# UNITED STATES PATENT AND TRADEMARK OFFICE

APPLICATION NO.	FILING DATE	FIRST NAMED INVENTOR	ATTORNEY DOCKET NO.	CONFIRMATION NO.
10/535,689	05/18/2005	Tomoyasu Ichiki	NAKA0103PUSA	7925
22045	7590	06/30/2008	EXAMINER	
BROOKS KUSHMAN P.C. 1000 TOWN CENTER TWENTY-SECOND FLOOR SOUTHFIELD, MI 48075			NGUYEN, TUAN N	
			ART UNIT	PAPER NUMBER
			3751	
			MAIL DATE	DELIVERY MODE
			06/30/2008	PAPER

<b>Office Action Summary</b>	<b>Application No.</b> 10/535,689	<b>Applicant(s)</b> ICHIKI ET AL.	
	<b>Examiner</b> Tuan N. Nguyen	<b>Art Unit</b> 3751

## DETAILED ACTION

FIG. 19

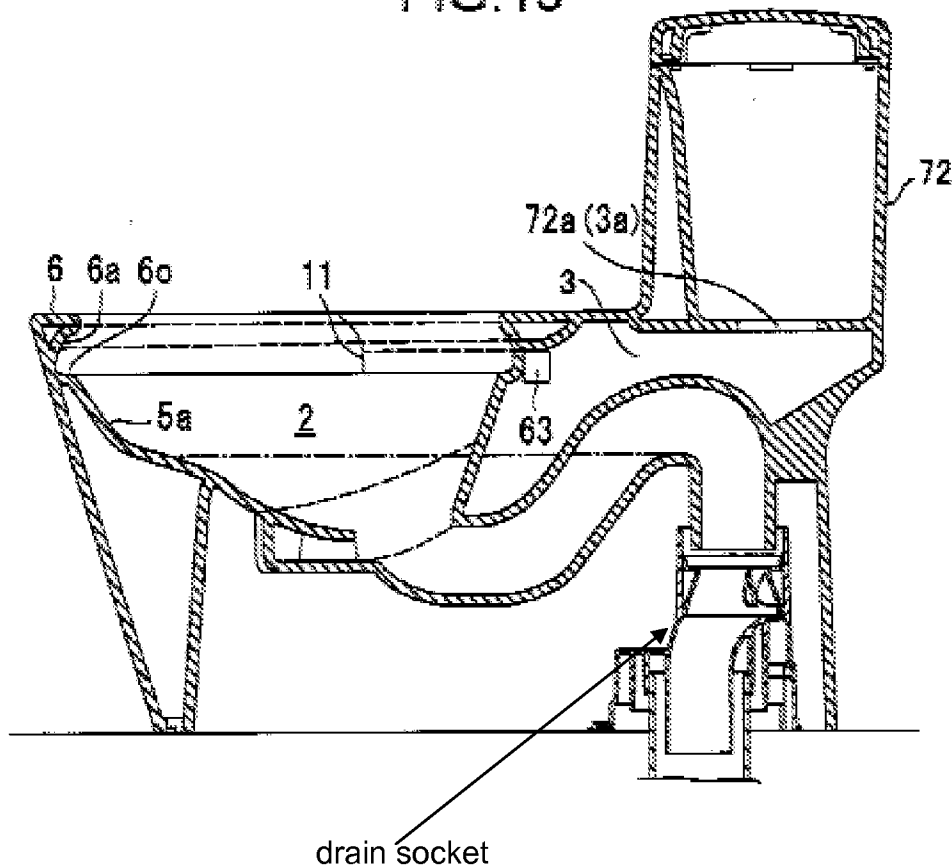
3. Claims 1-6, 10, 12-20, 24, 26-30 and 32-36 are rejected under 35 U.S.C. 102(e) as being anticipated by US 2006/0005310 A1 (hereinafter Nakamura)

Nakamura discloses a drain socket as claimed as shown below:
